Solicitation Addendum

Addendum No.: 1
Solicitation No.: IFBC No. 24-TA005325JH
Solicitation Title: Satellite Lift Station R&R Upper Manatee River Road, 2024 Group 1 and Group 2
Addendum Date: June 20, 2024
Procurement Contact: Jeb Hayter, Procurement Agent III

SATELLITE LIFT STATION R&R

28-A, RTU 130

PROPOSED

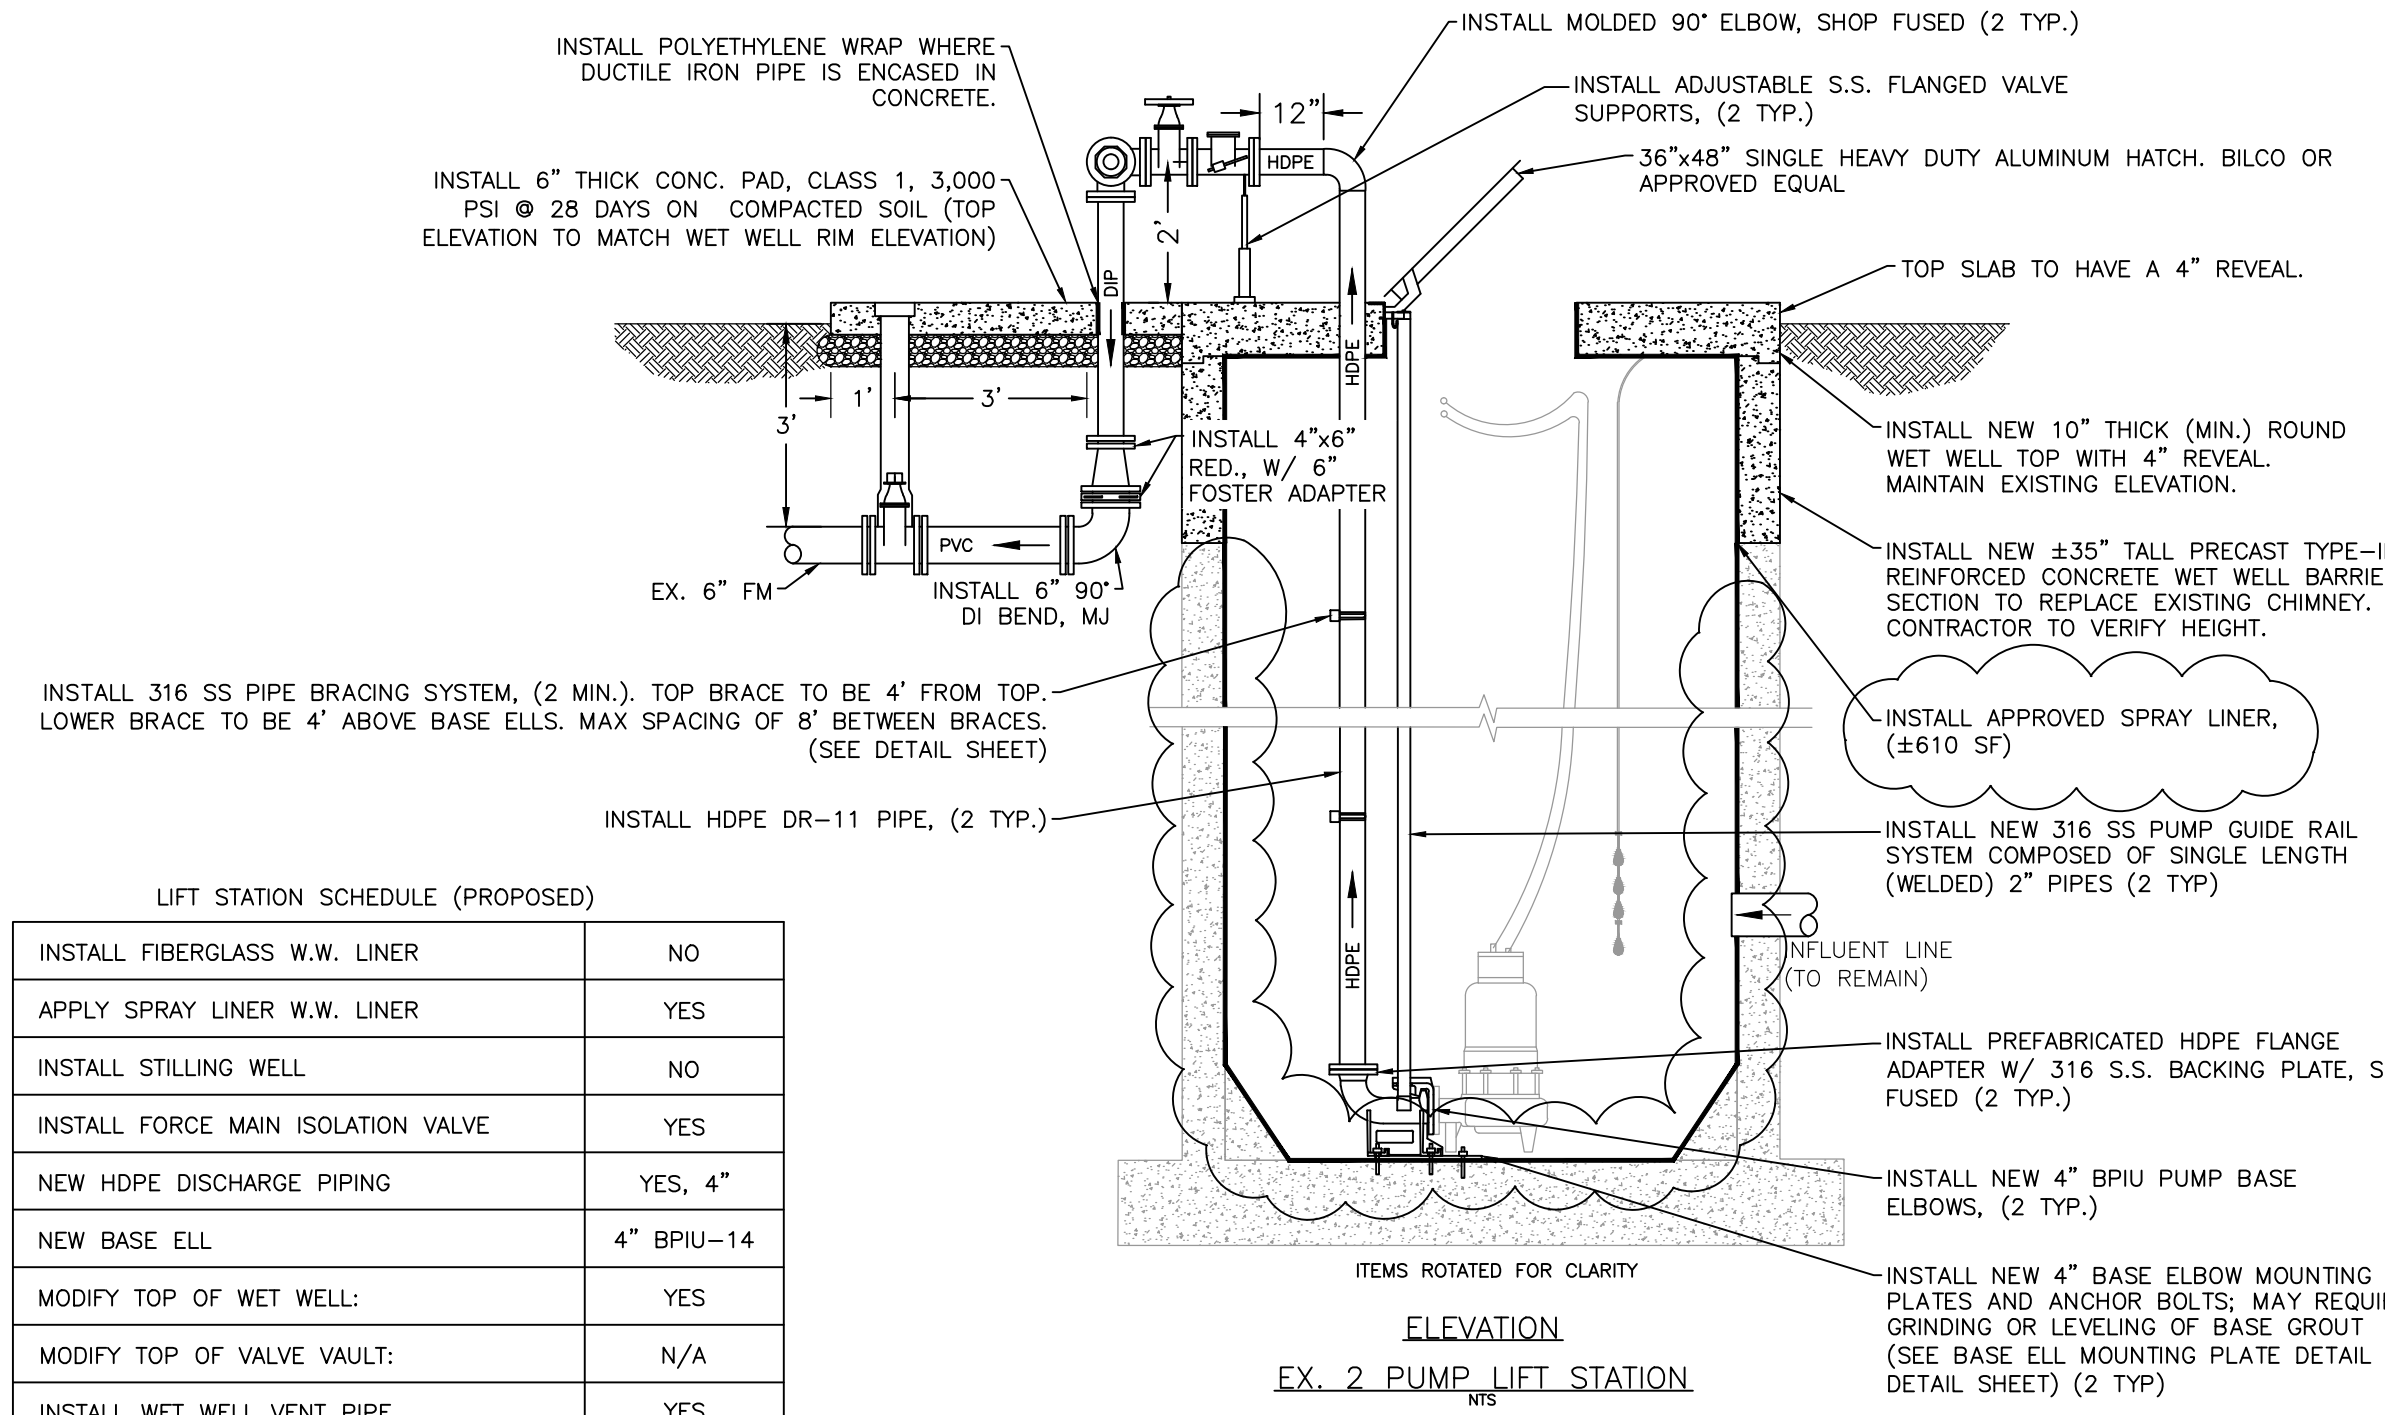
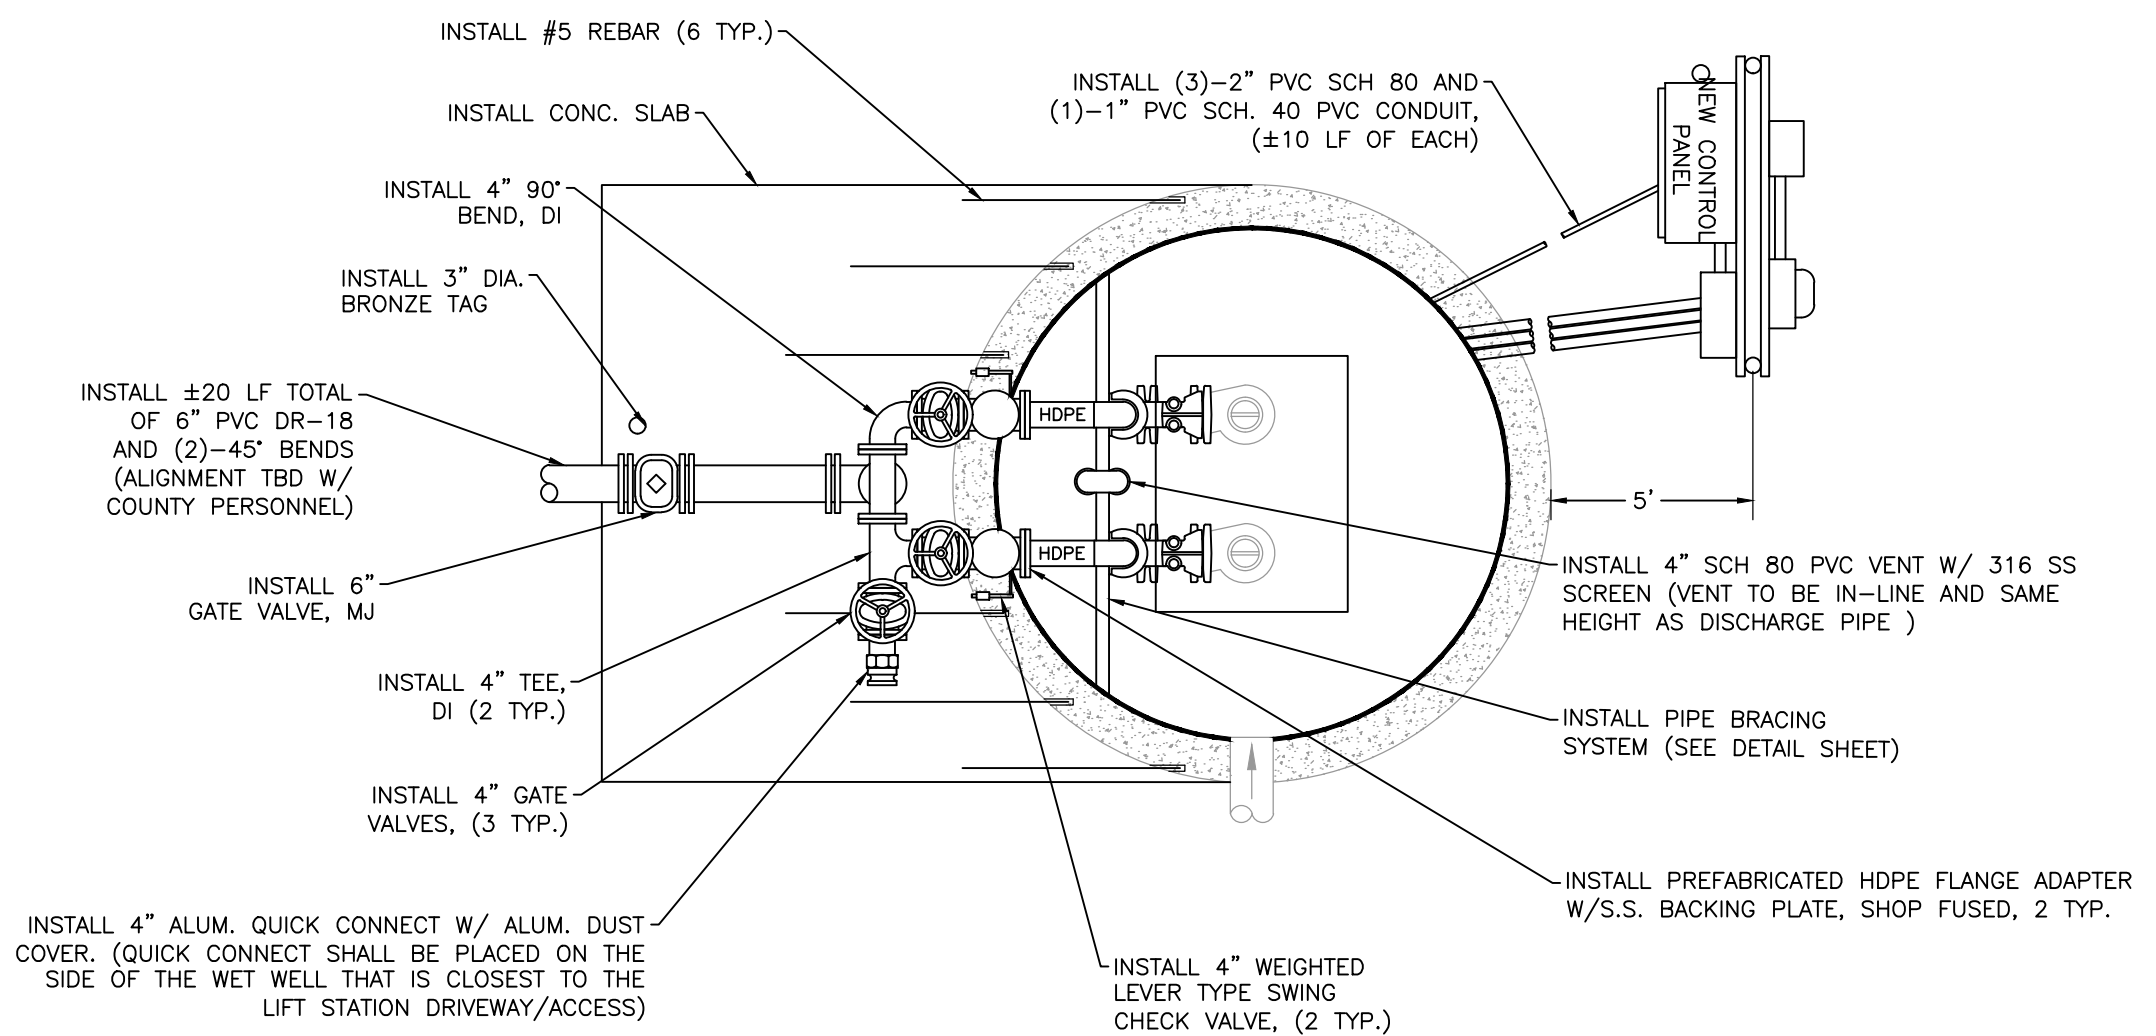
- Q12. 28-A RTU 130 states to use a County approved coating compatible with IET. Per my knowledge, there is no County approved coating that is compatible with IET? We suggest a full removal of the existing coating and full installation of a County approved coating, please advise.**
R12. The lift station has been modified to have the existing liner completely removed and an approved spray liner to be applied.

NO.	REVISION DESCRIPTION	BY	DATE
1	revised to completely remove existing wet well liner; revised manhole liner quantity	jss	6/18/24

INSTALL FIBERGLASS W.W. LINER	NO
APPLY SPRAY LINER W.W. LINER	YES
INSTALL STILLING WELL	NO
INSTALL FORCE MAIN ISOLATION VALVE	YES
NEW HDPE DISCHARGE PIPING	YES, 4"
NEW BASE ELL	4" BPIU-14
MODIFY TOP OF WET WELL:	YES
MODIFY TOP OF VALVE VAULT:	N/A
INSTALL WET WELL VENT PIPE	YES
INSTALL NEW WATER SERVICE ASSEMBLY	YES
RELOCATE EX. WATER SERVICE ASSEMBLY	NO
